**From:** Alex Popova <alex@oklo.com>  
**Sent:** Friday, April 12, 2019 6:03 PM  
**To:** Mazza, Jan; Lynch, Steven  
**Cc:** Joshua Richard; Jacob DeWitte  
**Subject:** [External\_Sender] NRC modeling document -- Oklo concerns  
**Attachments:** Oklo concerns with NRC modeling document.pdf

## ATTACHMENT – Oklo Concerns with NRC Modeling Document

### NRC NON-LIGHT WATER REACTOR (NON-LWR) VISION AND STRATEGY, VOLUME 1 – COMPUTER CODE SUITE FOR NON-LWR DESIGN BASIS EVENT ANALYSIS

### NRC NON-LIGHT WATER REACTOR (NON-LWR) VISION AND STRATEGY VOLUME 3: COMPUTER CODE DEVELOPMENT PLANS FOR SEVERE ACCIDENT PROGRESSION, SOURCE TERM, AND CONSEQUENCE ANALYSIS

*Figure B-23. MELCOR heat pipe temperatures for a transient-equilibrium test problem*

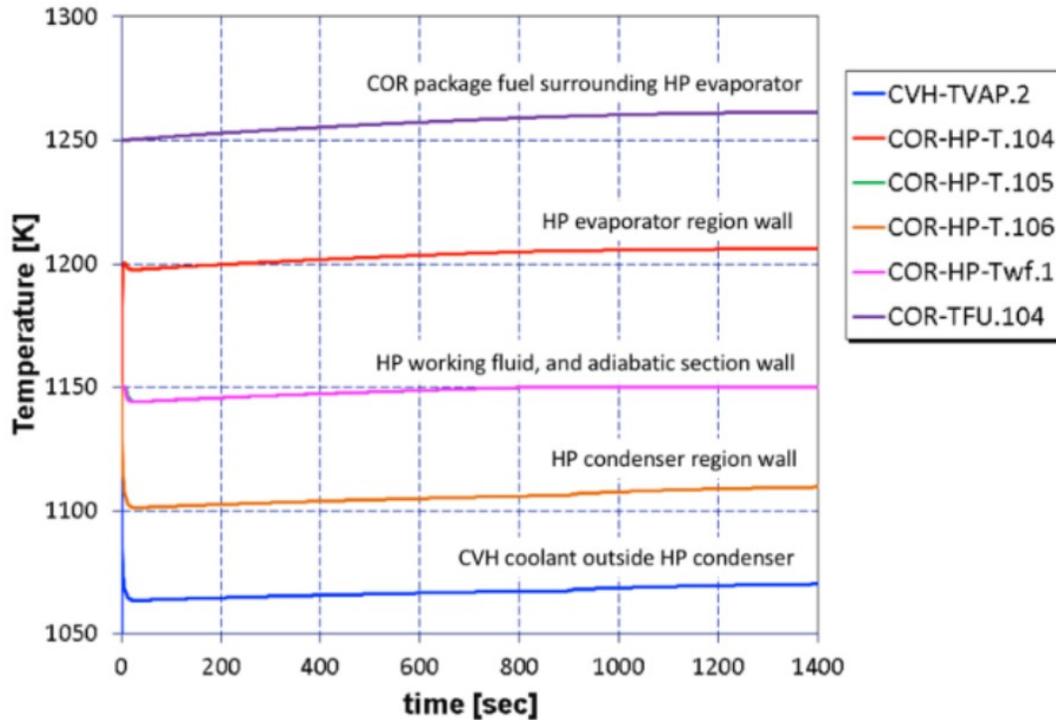
*Issue #6: Figure B-23, page 150, is replicated below:*

Reasoning: This figure discloses detailed fuel design information that Oklo usually considers proprietary information and ECI. Additionally, the removal of this figure from the report does not take away from the message conveyed in this report.

Suggestion: Delete this figure.
